Highways England's consultation response of 1 May 2018

Highways England Planning Response (HEPR 16-01)

Council's Reference: 18/00542/FUL

Referring to the notification of a planning application referenced above, in connection with the A38 and improvements to Caton Cross involving lengthening off-slip land and associated alterations to traffic island, road markings and adjacent footpath/cycleway, replacement and compensatory planting and temporary construction area within the highway on land at Caton Cross, A38 Devon Expressway, Ashburton, Devon, notice is hereby given that Highways England's formal recommendation is that we:

Drawing DR-L-0006-P01

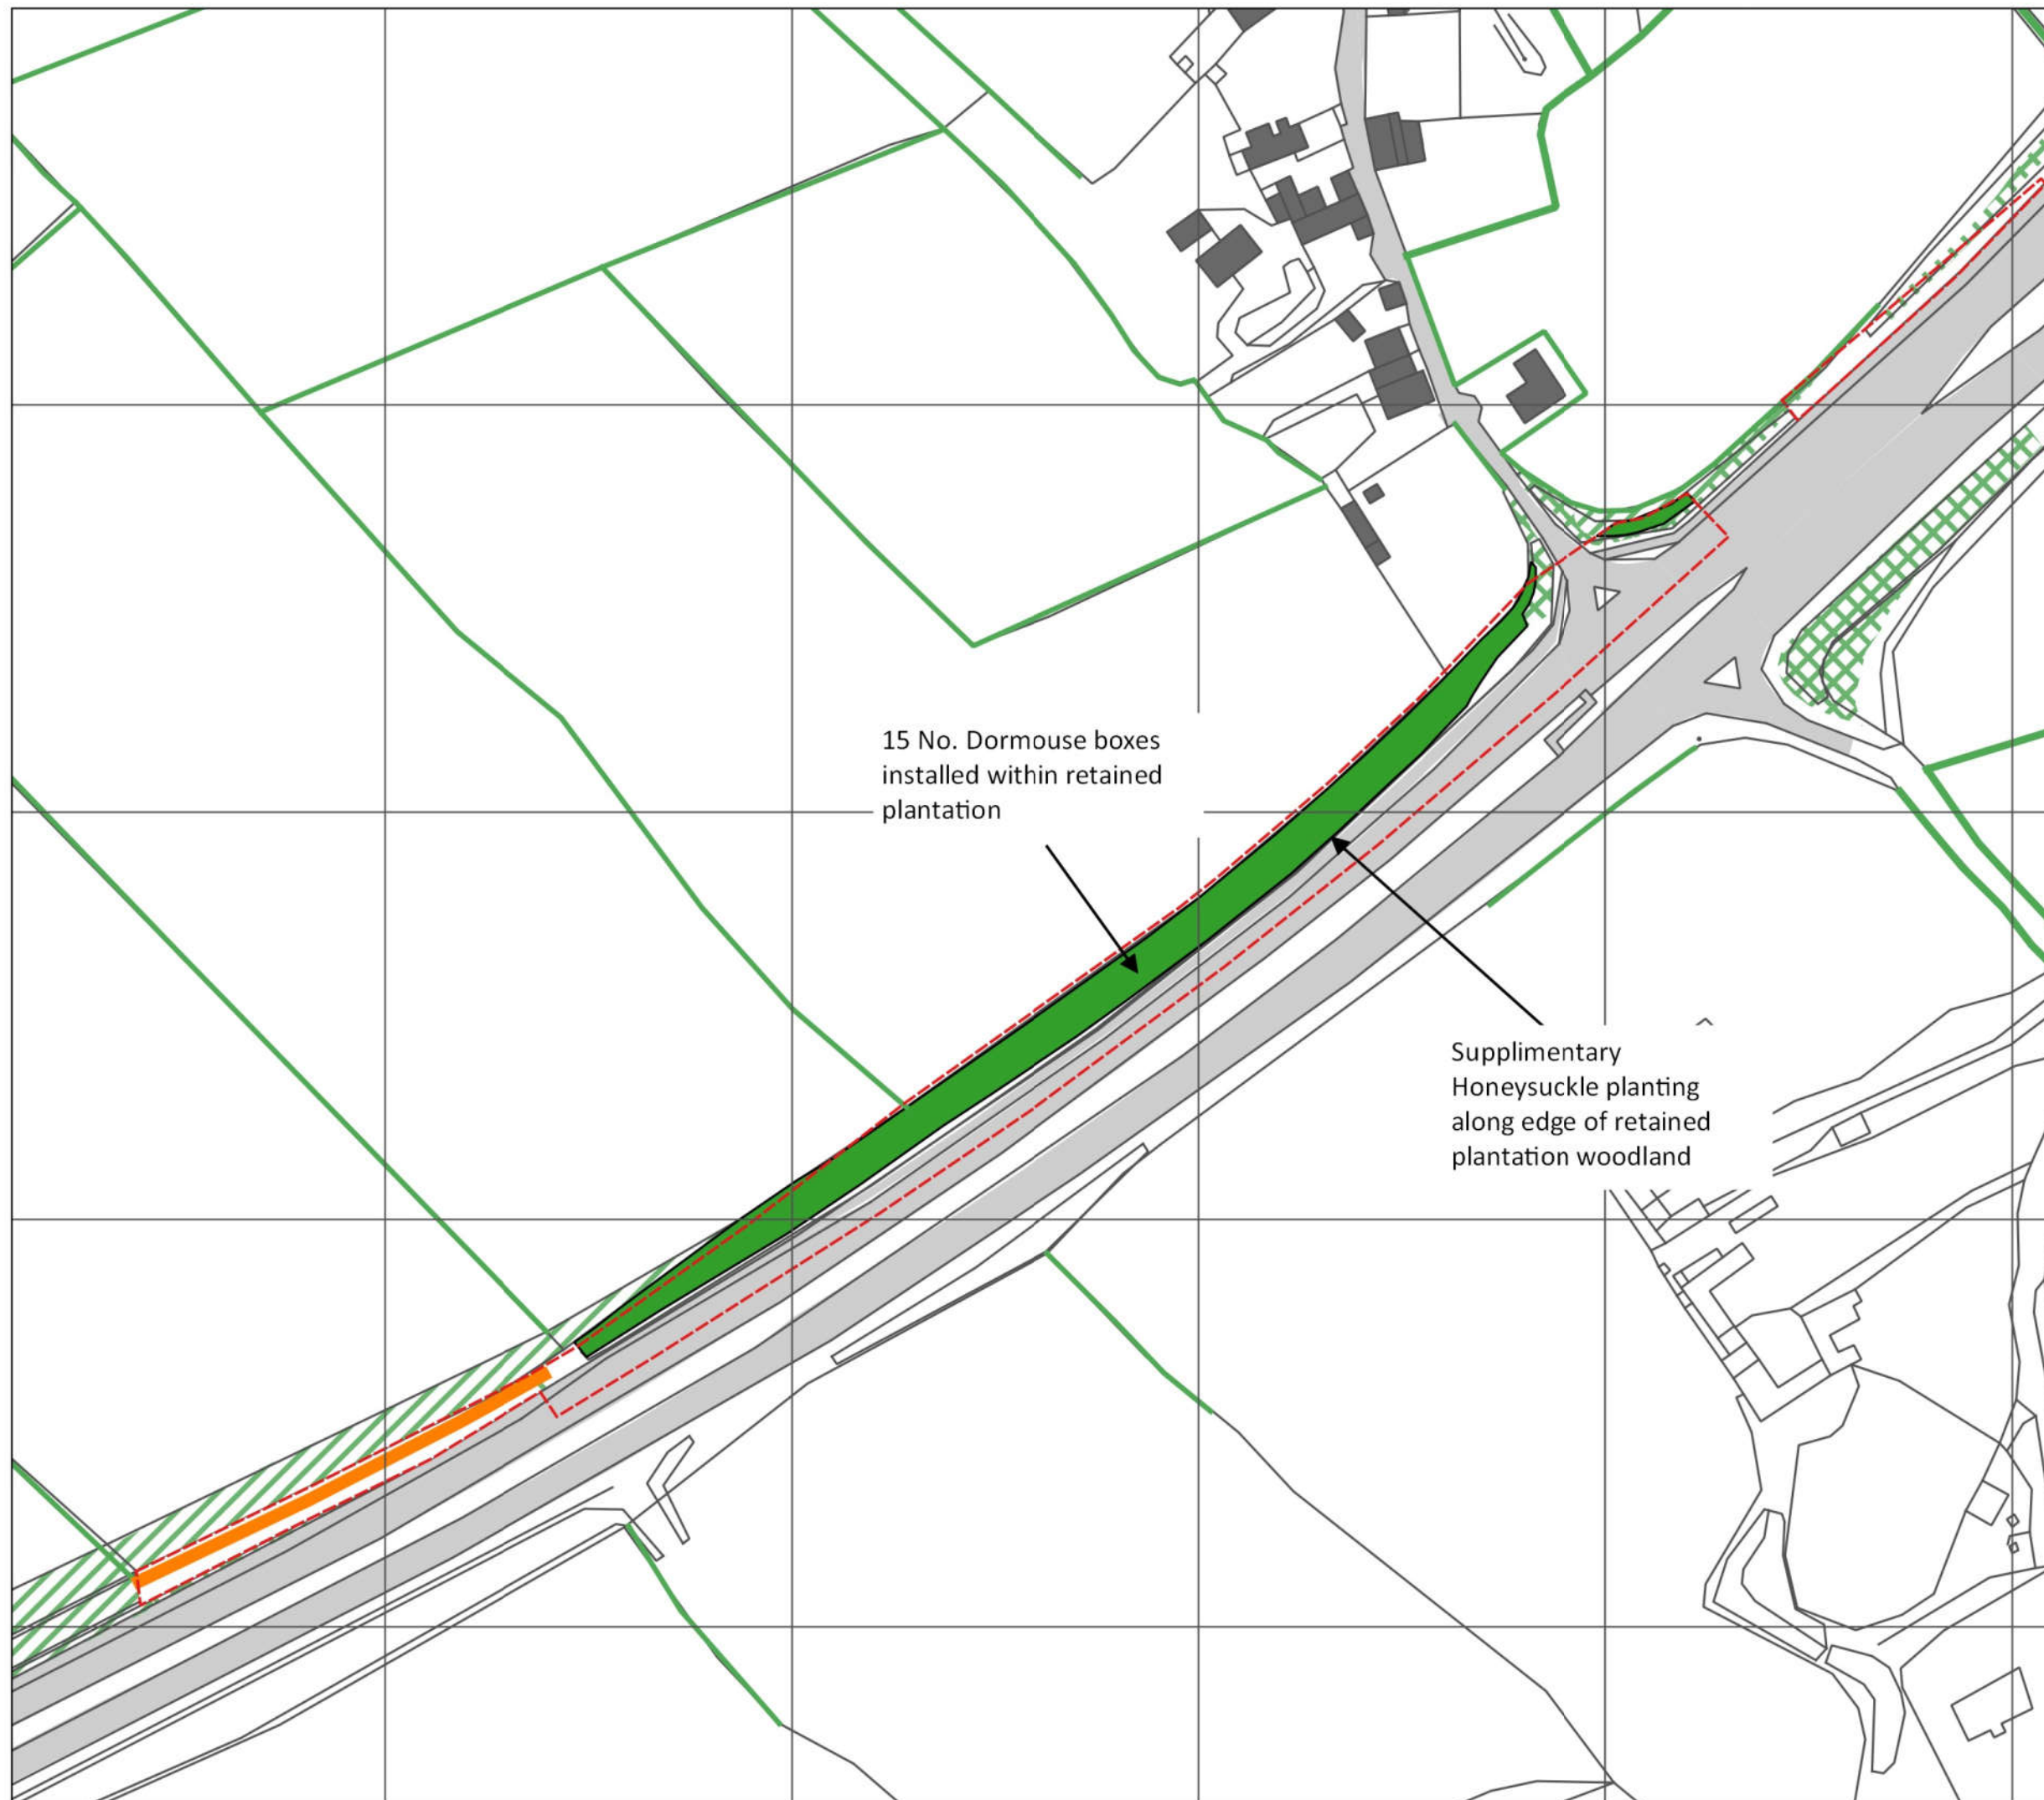
1. Plot A and Plot B are oppositely labelled to drawings DR-C-1005-P01 and ATK-GEN-T-PL-0004-P3, this needs to be amended.
2. No planting is acceptable within Plot A, east of the last ADS before the off-slip. This area provides forward visibility to the off-slip and the ADS is raised to enhance such visibility. The Highways England plot between the ADS and underpass should be open grassland and scrubby vegetation growth has been purposely removed here in recent years to improve forward visibility. Limited vegetation in the lower elevation of the plot has been left to provide some biodiversity connectivity.

3. No planting should be done in the shaded area identified as the "proposed shrub planting block". This area provides forward visibility to an ADS and has been assessed as satisfactory to its landscape type and function. Planting would compromise sign visibility and/or maintenance of the drainage ditch.

4. Honeysuckle planting at the back of the mature tree plot would be acceptable subject to our general comment at 1 above.
5. A minimum of 3 years aftercare should be specified for planting within Highways England soft estate.

6. Any contractor wishing to access Highways England soft estate should be formally inducted by an authorised Highways England employee.
7. No new planting is permitted within 3m of a road side barrier, this distance provides the required width for design function of the barrier and for operative/customer refuge area.

8. Common dogwood should not be planted within Highways England soft estate as it is high maintenance. Alternatives could be yew, spindle, field maple.
